ADDENDUM NO. 1

Reference: LHM Campus East Parking Lot Expansion
Salt Lake Community College ó Salt Lake City, Utah

Project No.10203660

Subject: **Addendum No. 1**

IRRIGATION CONTROLLER

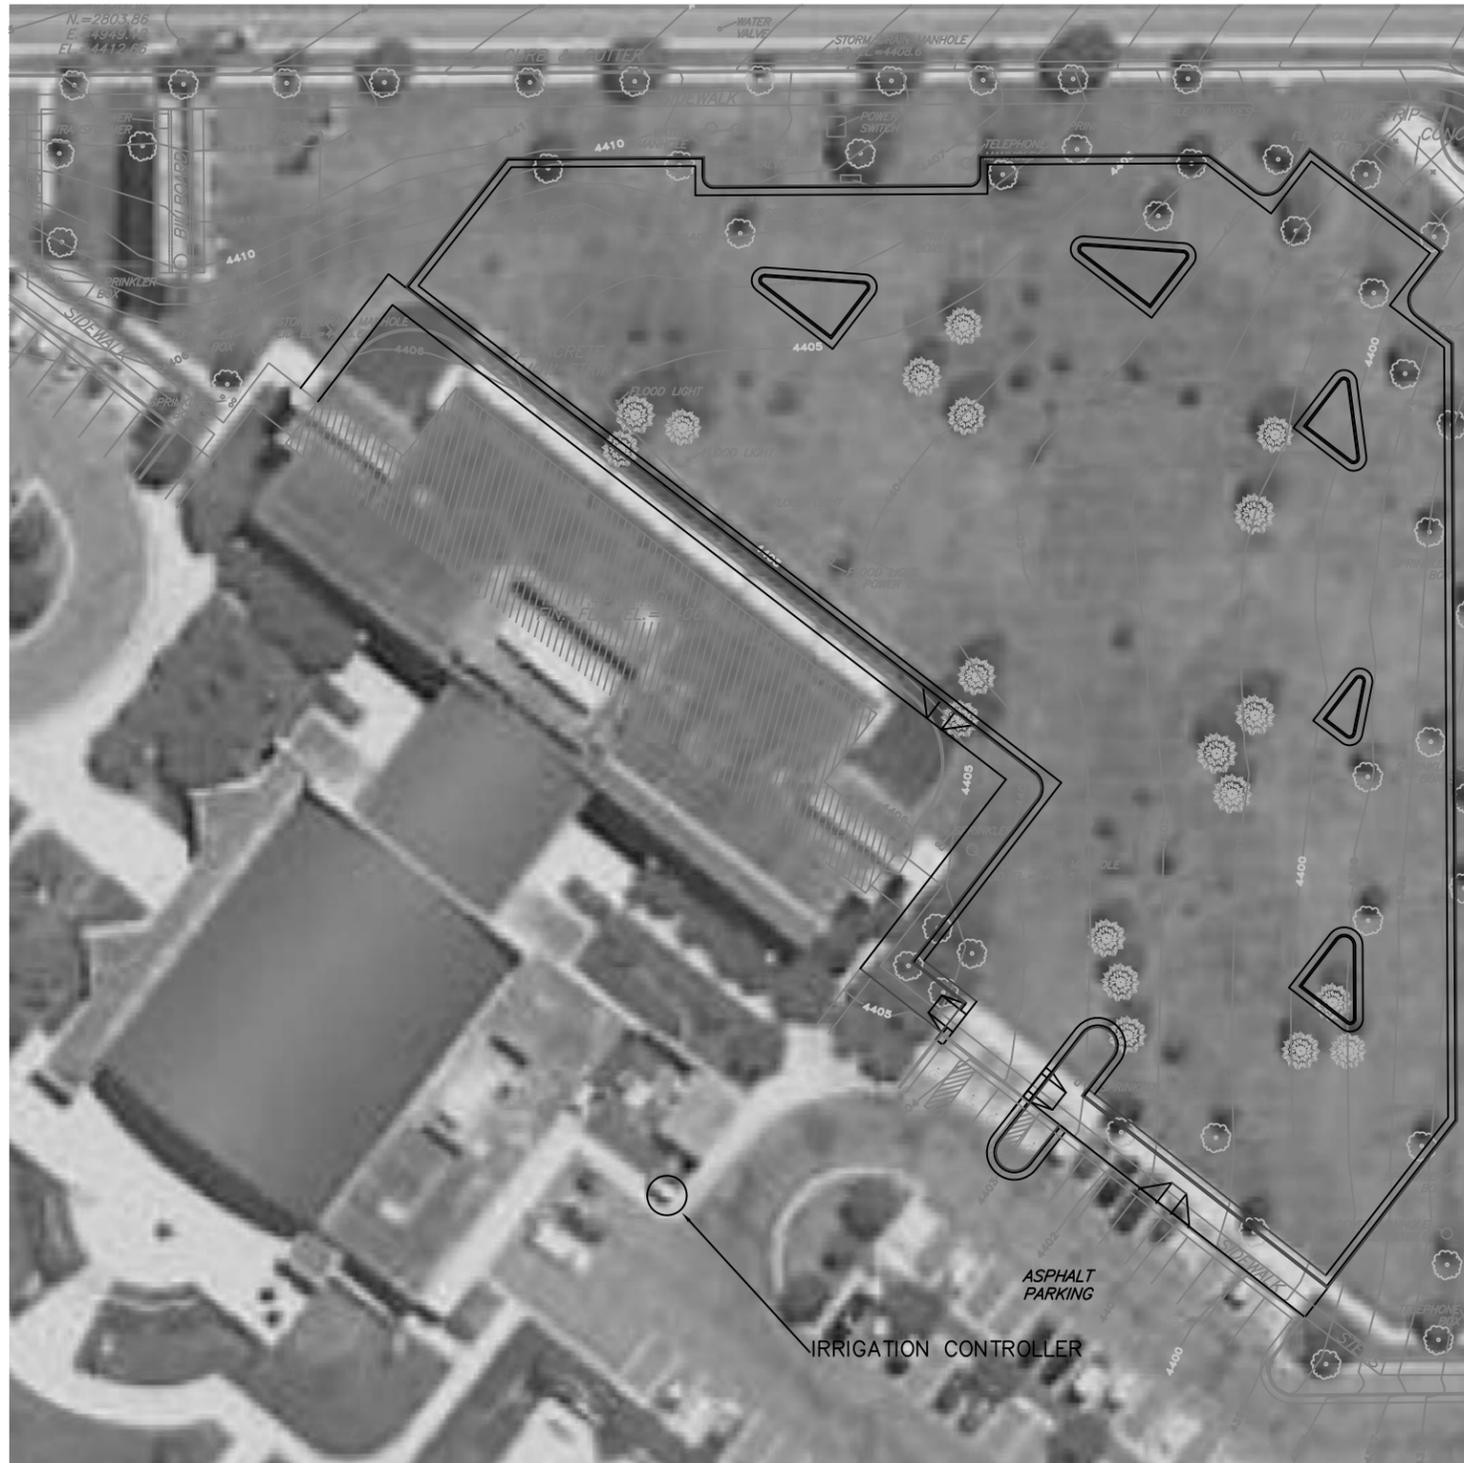
10. The location of the existing irrigation controller and clock are shown on Exhibit "A" of this addenda. As part of Bid Item No. 26, "Landscaping and Irrigation New Piping, Heads, Sod, Topsoil, Valves, Boxes, Drains, Connections, Complete" the contractor shall remove and replace the existing Rainbird ESP-32 MC SAT with cycle soak controller and CSA enclosure 3 with a new Maxicom compatible Rainbird ESP-32 MC SAT with cycle soak controller and CSA enclosure 3. The contractor shall reconnect all the existing valves to the new controller and connect to modem system. The contractor shall also remove and replace the existing Rainbird CCU-6 and CSA enclosure 3 with a new Rainbird CCU-6 and CSA enclosure 3 and connect to all existing valves and modem as required as part of this bid item.
